LeBreton Library Parcel

Constructability Report

February 2023 | TYLin Ref. 10399

Dream Asset Management

PROJECT No.	10399
FIGURE No.	1-1

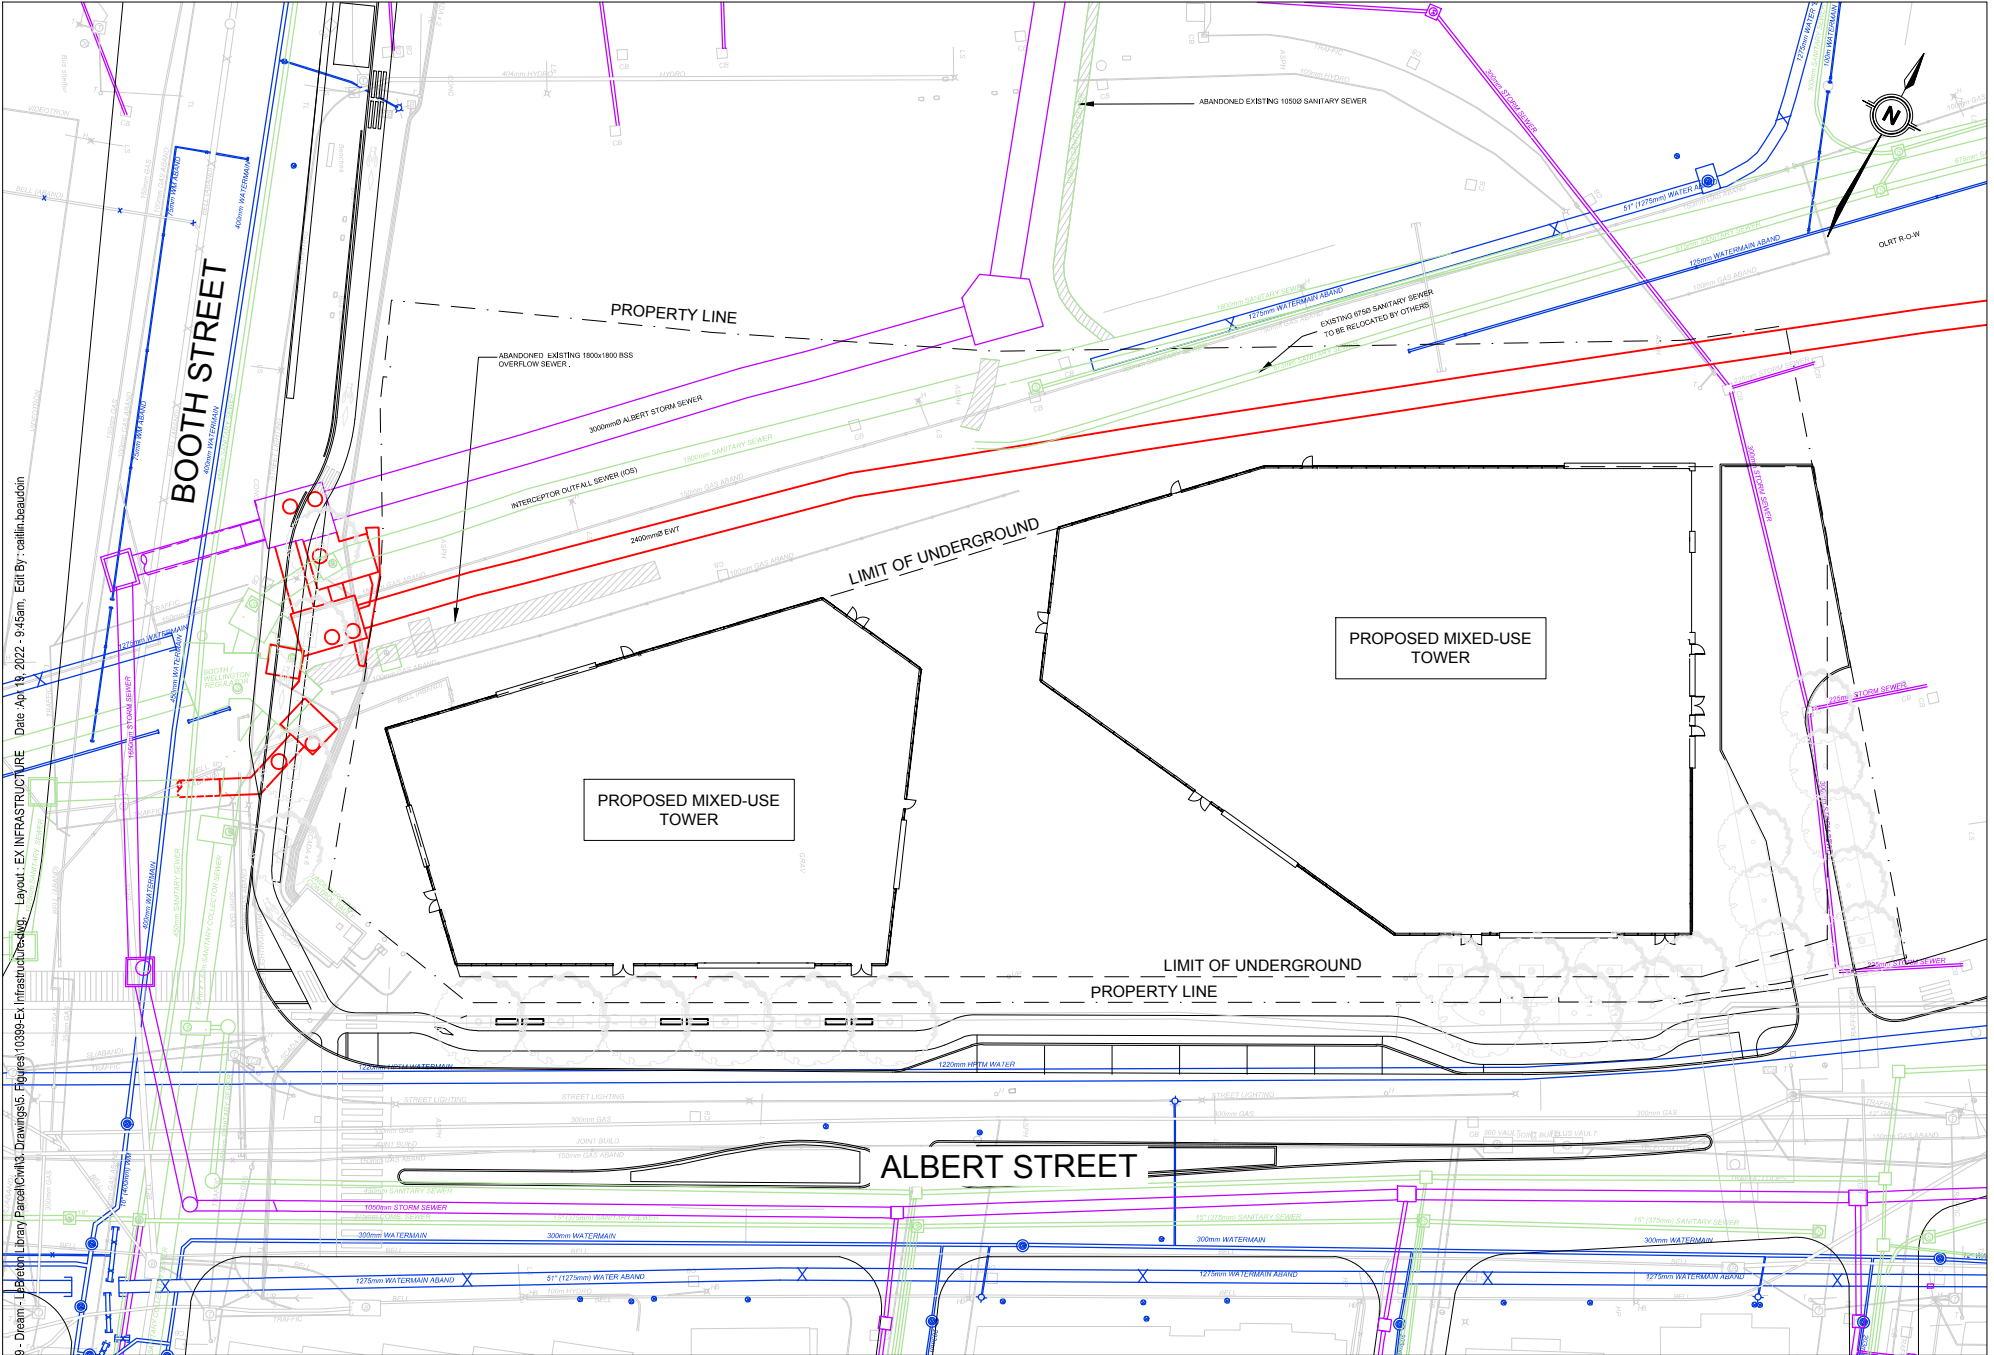
- a. The plans included within the constructability report (Figure 1-1) appears to show the existing Real Time Control (RTC) underground control vault at Booth/Albert and the associated underground ductbanks from this vault to the RTC facilities. It is unclear how/if the infrastructure is affected by the work, but this should be reviewed and addressed by the proponent. Excavations may extend into the footprint of the vault and the ductbanks, potentially requiring temporary support and protection.

- a. The plans included within the constructability report (Figure 1-1) appears to show the existing Real Time Control (RTC) underground control vault at Booth/Albert and the associated underground ductbanks from this vault to the RTC facilities. It is unclear how/if the

Figure 3-1 LLP-LOG-02 Extract

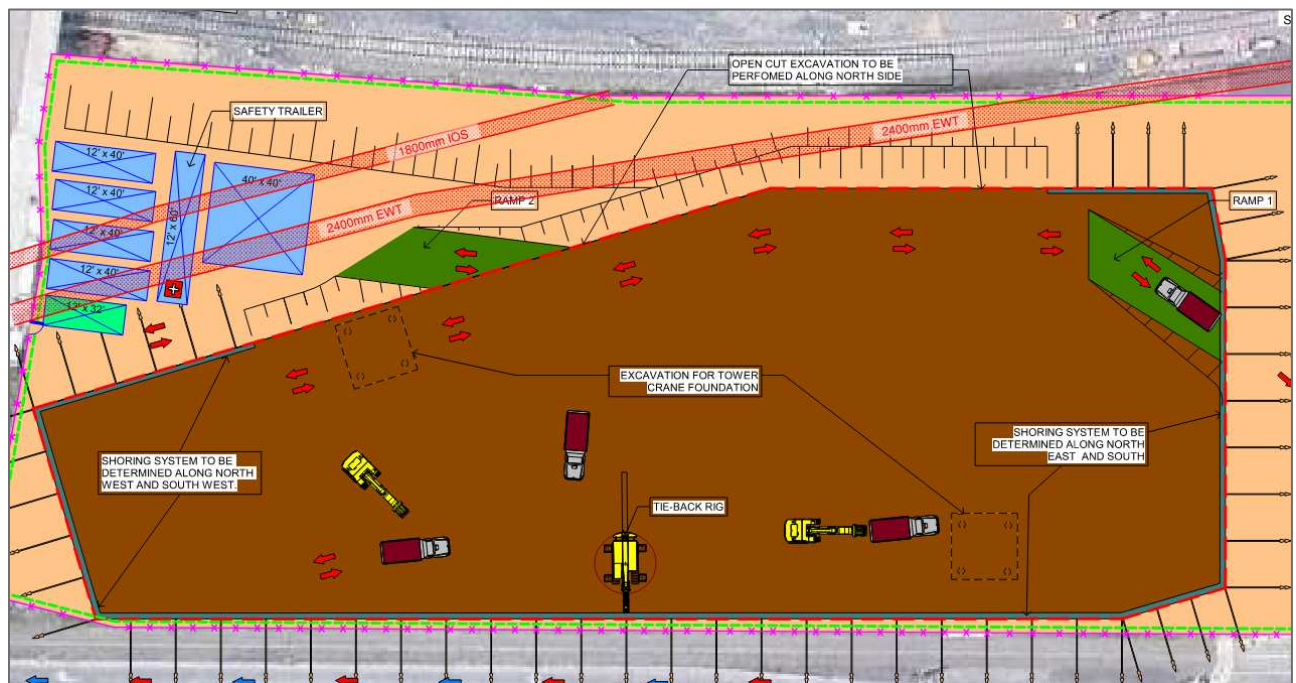
Revised report does not address comment fully. However, landscaping cross-sections illustrate that final grades for the MUP (lowest elevation area of site) will be at 56.0m at a minimum, consistent with the grades of the existing LRT tracks that are above-adjacent to the existing sewer infrastructure. It is assumed that the construction site overtop of the EWT and IOS will not be excavated lower than 56.0m outside of the shoring system (essentially existing grades). Provide confirmation whether any protective measures would be required to protect the sewers from construction activity/equipment.

In response to this comment, we note that no excavation lower than 56.0m is proposed over City infrastructure. As per the ED Logistics Plan Excavation Figure LLP-LOG-02 (**Appendix F**) and Marathon Shoring Plan (**Appendix E**), construction site grades in the northern portion of the site over existing City infrastructure will generally not vary significantly from the existing condition. As indicated in **Figure 3-1** (a marked-up extract of the Ellis Don Logistics Plan Grading Figure LLP-LOG-02 to show approximate alignment of EWT/IOS), City infrastructure lies outside of, or close to, the indicated top of slope linework. In localized areas some precut (to an elevation of 59.0m) will be necessary as part of excavation shoring (see Marathon Drg. MU4). On this basis, no additional protective measures are considered necessary.

CLIENT	DREAM	
PROJECT	FOUNDATIONS ANALYSIS LEBRETON LIBRARY PARCEL, OTTAWA, ONTARIO	
TITLE	CROSS-SECTIONS	
CONSULTANT	YYYY-MM-DD	2022-12-15
	DESIGNED	---
wsp GOLDER	PREPARED	JM
	REVIEWED	---
	APPROVED	---
PROJECT NO.	CONTROL	REV.
22511882	0006	A
		FIGURE
		1

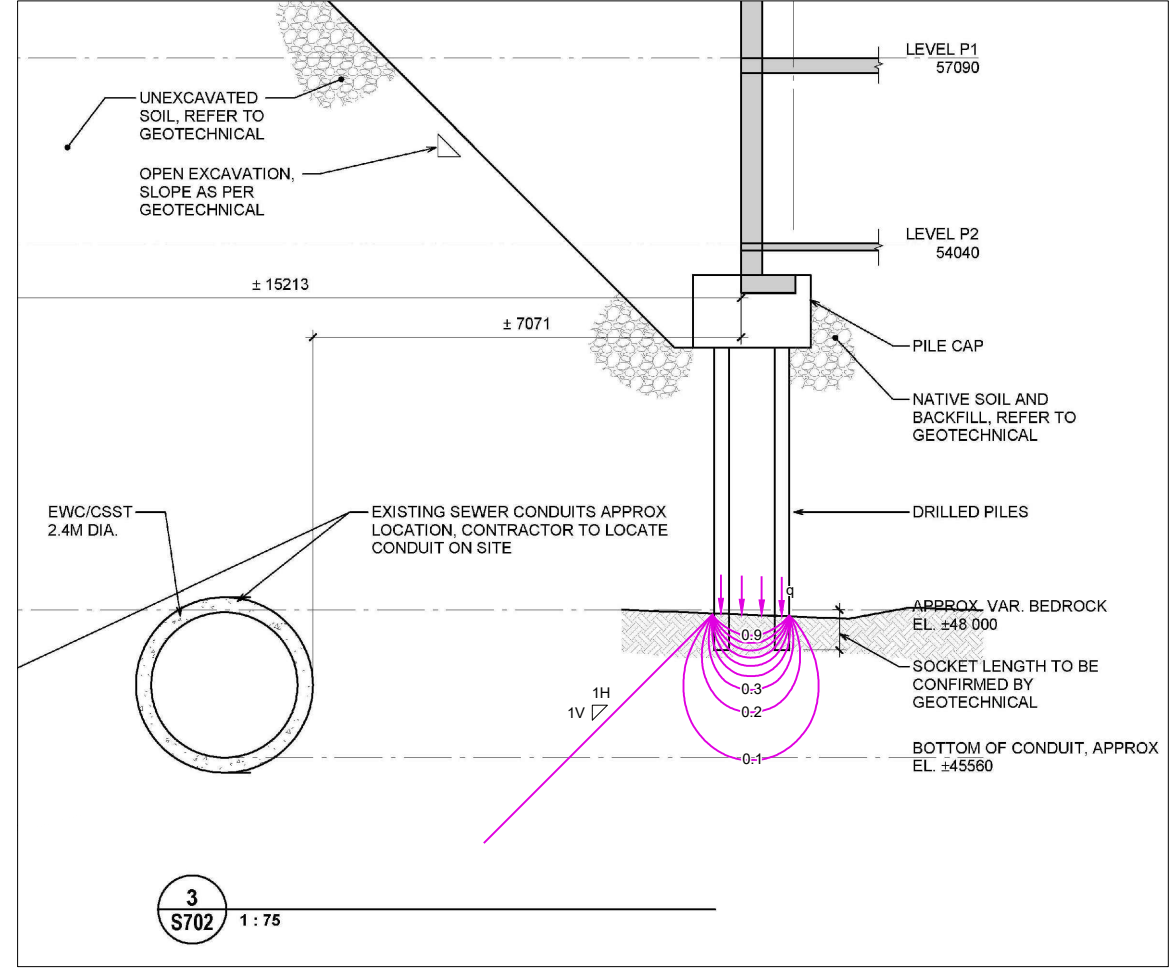
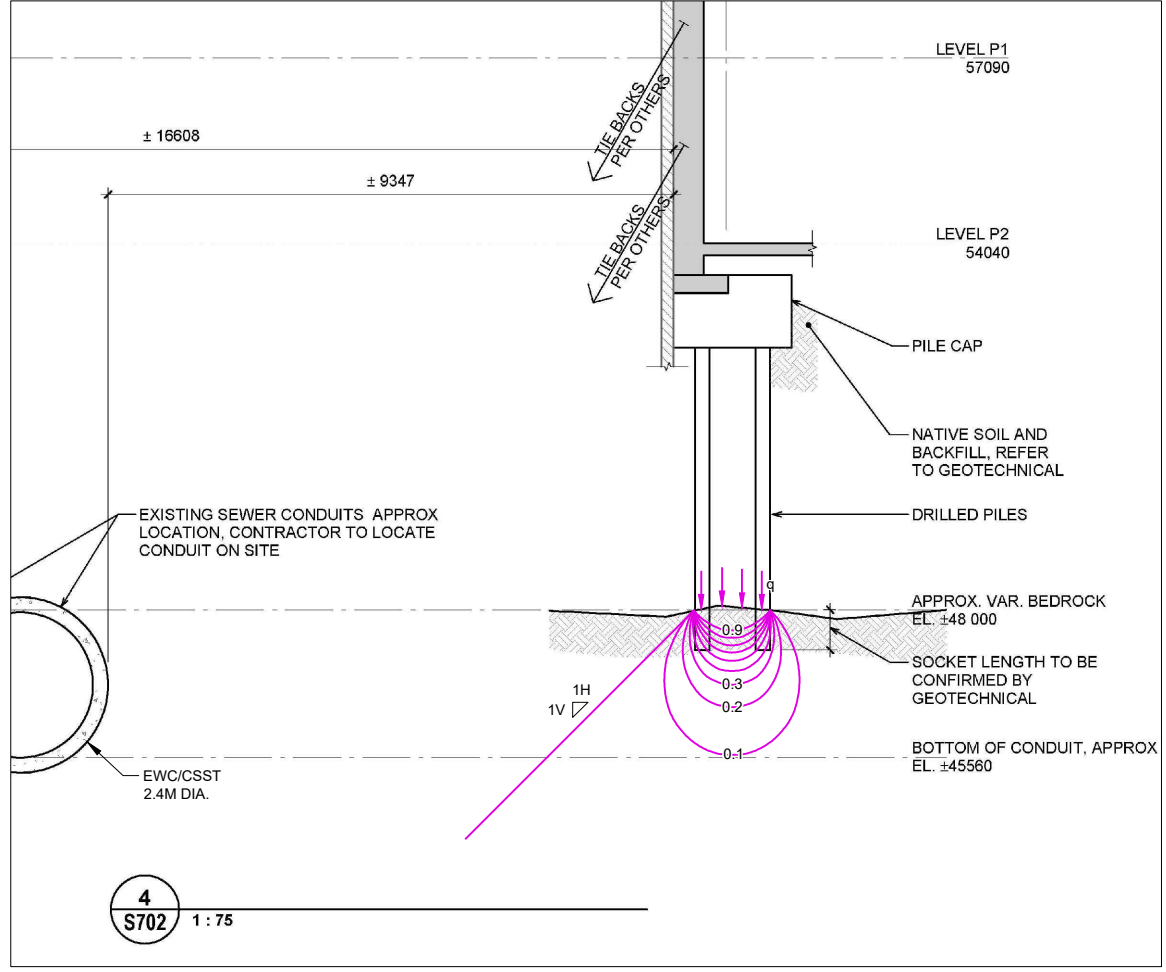
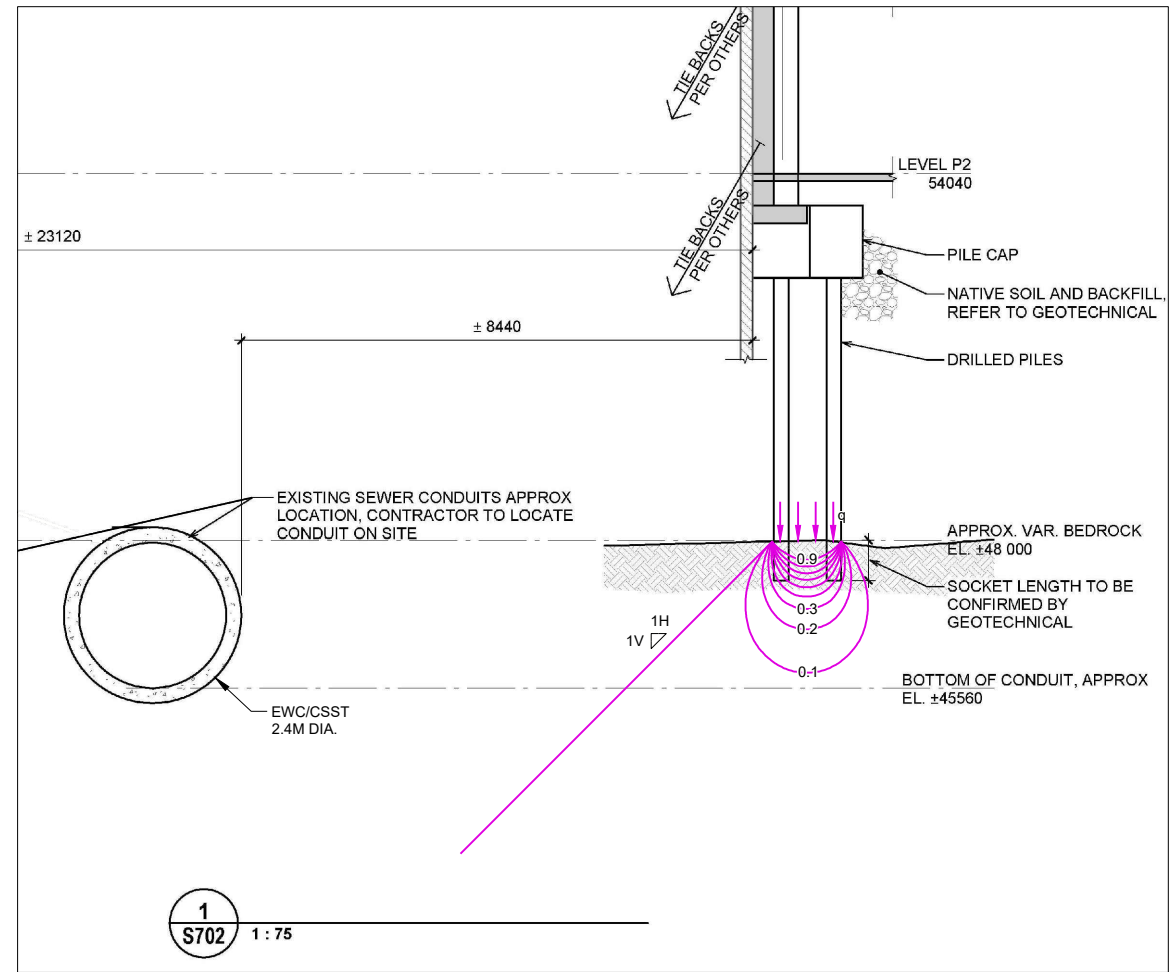
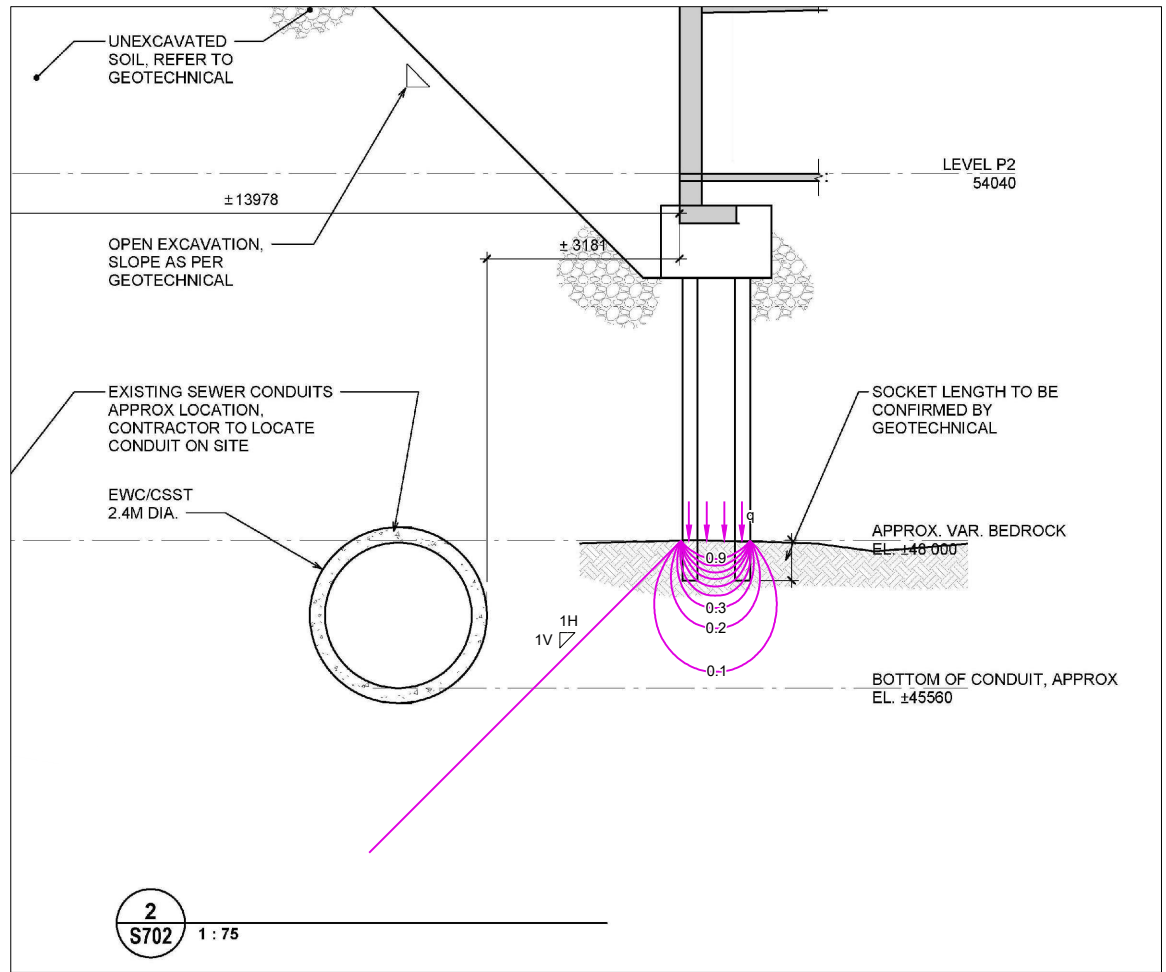
2. **Drawings and Construction Plans:** The developer should provide plans showing details of the proposed shoring system and permanent underground works, showing details on proximity to the EWT at several cross sections along the development. The cross section should also include any required temporary shoring and/tie backs that may be required to perform the work, including limits of excavation.

- Comment 3a: Golder has reviewed the foundation drawings and confirms that there are no additional loads expected to be applied to the EWT by the proposed foundations.
- Comment 3b: The current RJC drawings indicate that the caisson foundations will have a diameter of 1.2 m and will have a rock socket depth of 3 to 4 m.
- Comment 3c: The statement is not included in the geotechnical report because the foundations were not designed at the time of preparing the report. We believe this statement in the constructability report refers to subsequent correspondence and discussion. Regardless, it is Golder's opinion that the currently proposed foundations should not impose any significant stress increase to the existing services in question and, notwithstanding the reference, the statement in the constructability report is generally valid.

- Comment 3d: The caissons are designed to have a rock socket depth of 3 to 4 m which is approximately 3 times the proposed diameter. This would typically be sufficient to be considered fixed (though the quality of the rock sockets does need to be confirmed during construction).

- Comment 3e: Given the discussion above, the increase in stress due to the permanent foundations is expected to be essentially zero.
- Comments 4a to 4e: These comments relate to shoring and temporary works which are designed by others. Golder would be pleased to provide additional review as required as these aspects of the project are designed in further detail.
